Highway-Rail Grade Crossing Review

*Prepared by CTC, Inc., for
Metro-North Railroad*

July 28, 2016

Tuxedo Park, NY
East Village Road
DOT # 263501F, MP 37.30
Port Jervis Line

Figure 5 - Circuit Plans

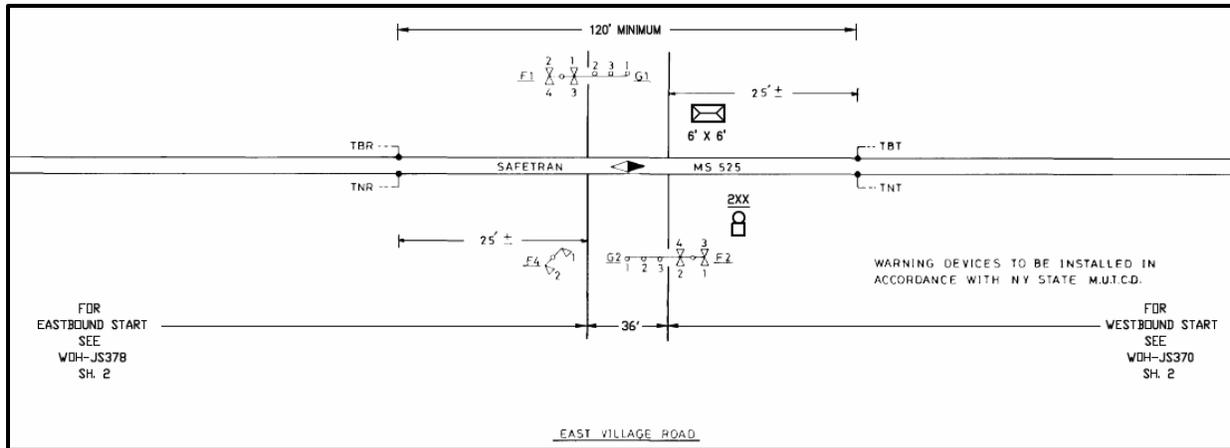
Trains approaching, slowing and stopping at Tuxedo Station activate the warning devices at the grade crossing. As a result, long warning times much greater than the designed warning time of 30 seconds were observed. The vehicular traffic and pedestrians associated with the station stop cause congestion and queuing of vehicles at the crossing.

Figure 9 - Traffic Signal and Restriping

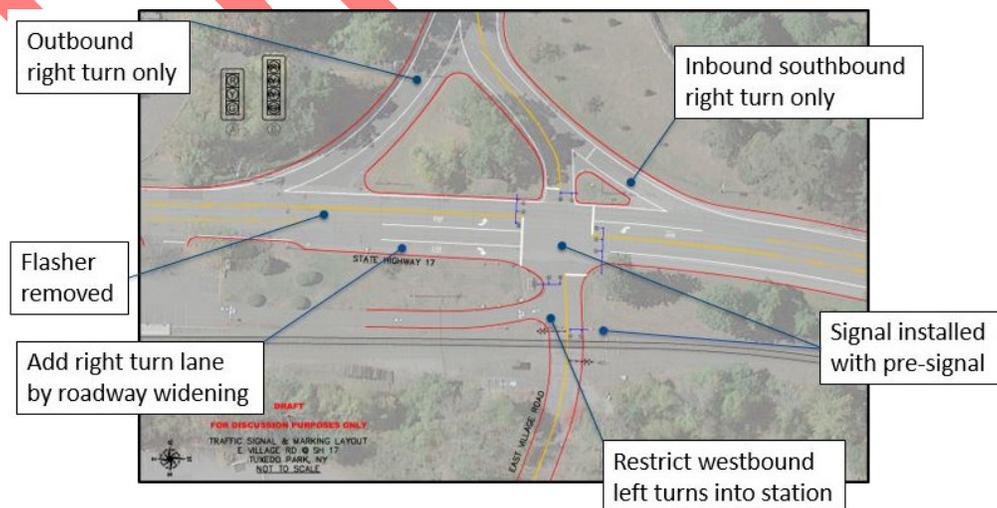
- **Consider the installation of a traffic signal at the intersection of East Village Road and State Highway 17 to provide a track clearance movement for the tracks. Due to the steep grades approaching the crossing, a pre-signal should also be installed. Reconfiguration and realignment of the entrance to Tuxedo Road may be required along with State Highway 17 re-striping. A conceptual design is shown in the figure below.**

Figure 10 - Pedestrian Gates and Sidewalks

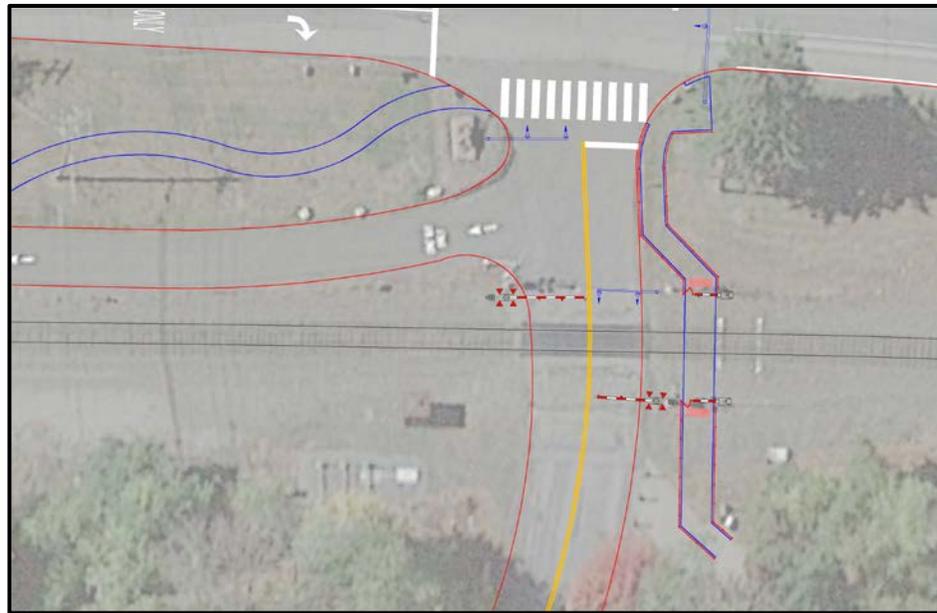
- Consider installation of a sidewalk and ADA accessible pedestrian ramp on the north side of East Village Road and connect with a crosswalk at the intersection of State Route 17. Fencing will be needed to force pedestrian to use the provided pathway and not meander across the roadway. A designated path could then be provided from the southeast corner of the intersection at State Route 17 to the station as shown in figure 10 below.

- Implement a pedestrian emergency exit route behind the gates to allow pedestrians to escape the tracks without resorting to entering the traveled roadway or lifting the gate. The existing sidewalks and location of automatic gates leave pedestrians stranded

between the lowered gates within the minimum track clearance distance. This forces pedestrians to enter the roadway and walk around, lift the gate or walk under the lowered gate. Proposed new language for the next edition of MUTCD recommends that sidewalks be relocated behind the roadway gates. Fencing and pedestrian gates are then used to control pedestrian access while still allowing for an escape route to prevent stranding pedestrians between lowered gates.
